Release Note for AIC SAS 6G 2U24-2 Expander

Jan 14, 2013

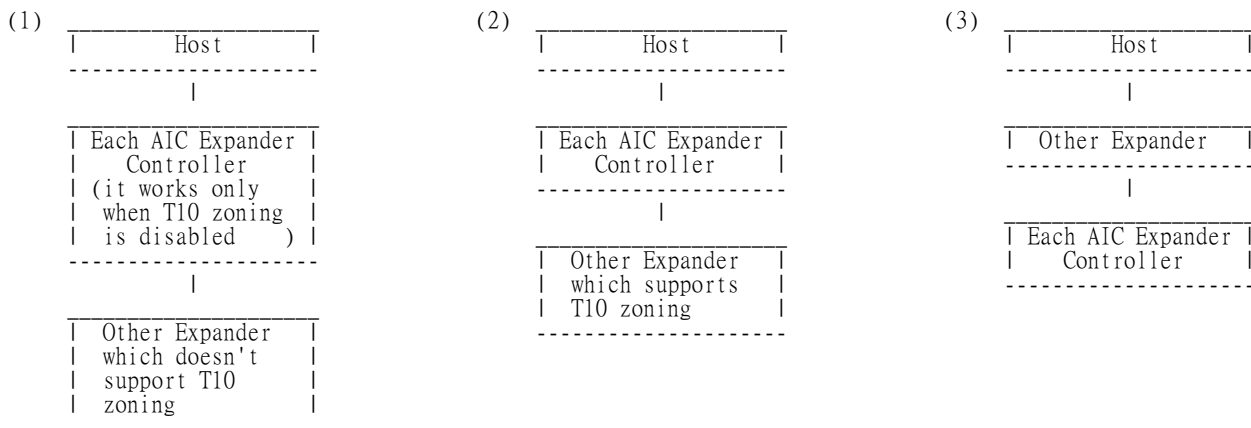
03/06/2012 (firmware 1.11.1.1 + mfg 1.1.x.2)

1. Improve signal for SATA drive
